Park Maintenance - Parks Toolhouse

Accessibility Review

Park Maintenance - Park Toolhouse
Proposed Entry
City of Duluth, MN

Photo 4: A new locker room area was created. Add an accessible bench (42" min x 20-24") with a back (or positioned against the wall).

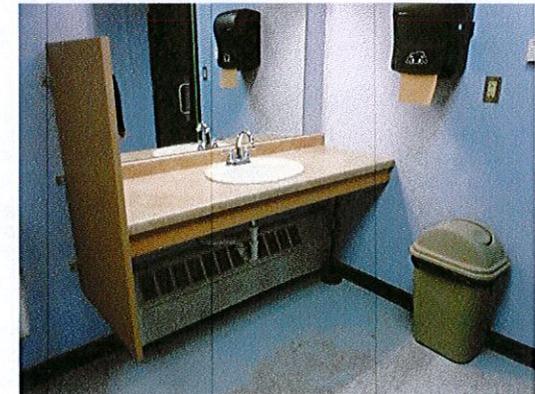
| Location JQP # / Item # | Solution / Comments | Qty | Unit Cost | Total Cost | Priority | Estimated Compl. Date | Person Responsible | Actual Compl. Date | Actual Cost |
|------------------------------------|--|-----|-----------|---------------------------|----------|--------------------------|-----------------------|--------------------------|----------------|
| 24V 15639 | In the changing/locker room, provide a bench, 20"-24" deep x 48" long, fixed to the wall or with a back along the longer dimension. The bench is to be mounted 17"-19" above the floor at the accessible dressing room and provide clear floor space at the end of the bench. MN1341 903 <i>Photo 4.</i> | 1 | \$200 | \$200 | 3 | | | | |

Provide an accessible bench

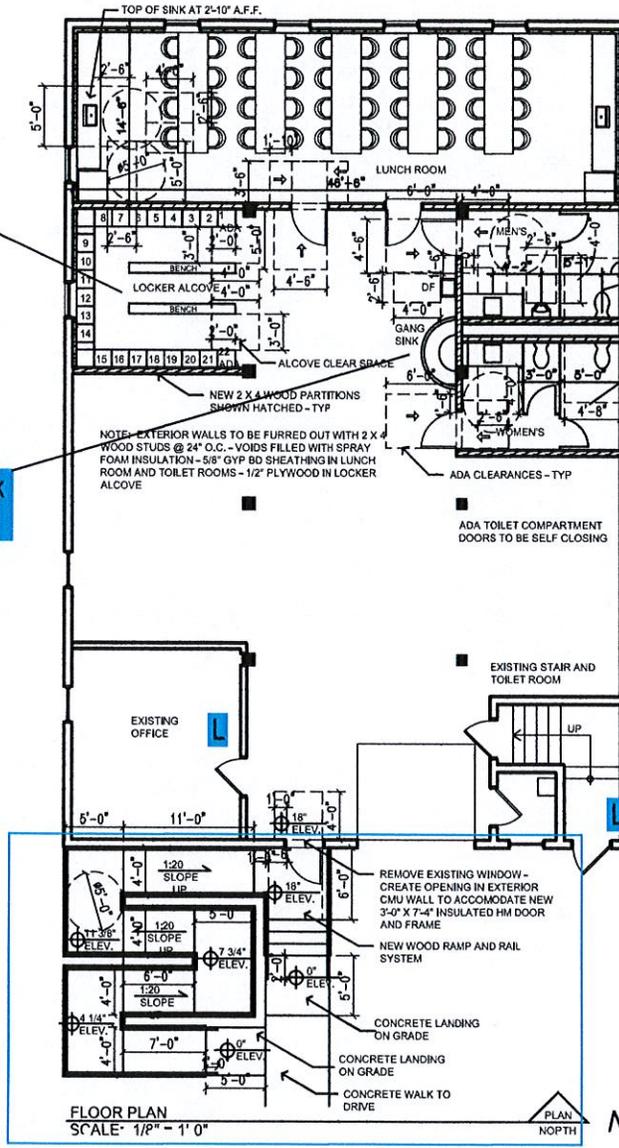
Provide accessible controls for sink
Lower the towel dispenser

Relocate the sign
Add staple style pulls to accessible stall door
Lower the coat hook
Insulate the pipes at the lavatory

Create an accessible route to the upper level
